Access Compliance Report Public Rights-of-Way (Curb Ramps)

Main Street: SALMON_DR Cross Street: OAK_WAY_DR Location: NW

ADA ID: RPRK211209112553 Ramp Type: Type 1 - Perpendicular Diagonal Initial Pass/Fail: Pass Overall Compliance: No Severity Score: 15

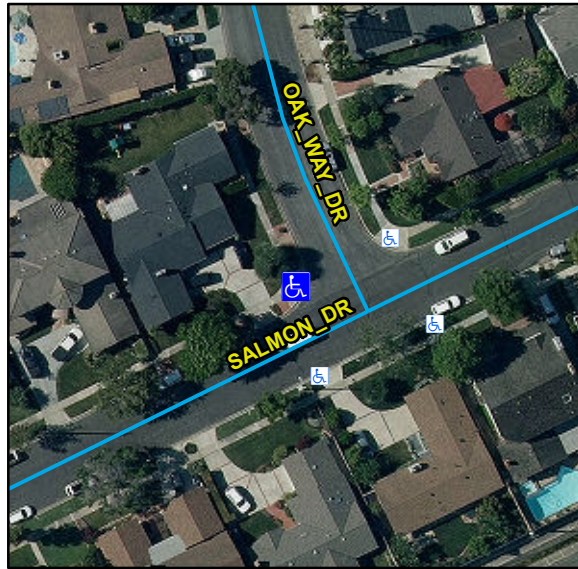
N/A	Ramp Inside Crosswalk 1	N/A	Yes	Ramp Inside Crosswalk 2	N/A
	Crossing 1 Slope (%)	6.6		Crossing 2 Slope (%)	1.9
	Crossing 1 Cross Slope (%)	2.7		Crossing 2 Cross Slope (%)	1.6
Yes	Gutter Ponding	No	Yes	Curb Slope	1.2
Yes	Gutter Lip Height (in)	0		Road Run Slope (%)	2.4
No	Gutter Run Slope (%)	8		Road Cross Slope (%)	7.7
No	Gutter Cross Slope (%)	3			
Yes	Overall Surface Condition: Acceptable		No	Perp Joint Present	No
	Cross Gutter Present?	No		Spandrel Present?	No
	Replace Cross Gutter?	N/A		Replace Spandrel?	N/A

Remove & Replace Curb Ramp With Two New Directional Ramps or Equivalent. Remove & Replace Gutter.
